IKE 458-5-4T - refrigeration unit does not function

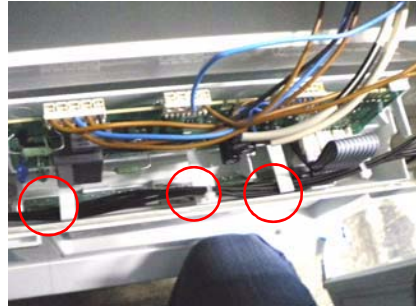
With appliances produced in the period from serial number 817 xxx xx and serial number 005 xxx xx, faults and blockages may occur in the main electronic system of the refrigeration unit.

This error, which only occurs when the refrigeration unit is switched off, is caused by electromagnetic interference fields which are in turn generated by the cables that are located behind the circuit board microprocessor and which regulate the refrigeration unit.

The display electronic unit does not show an error code and the display is switched off.

Solve the problem by reconnecting the cables as described below. The electronic unit does not need to be replaced. It is absolutely essential to ensure that the electronic unit connections are not moved/displaced when the cables are re-arranged.
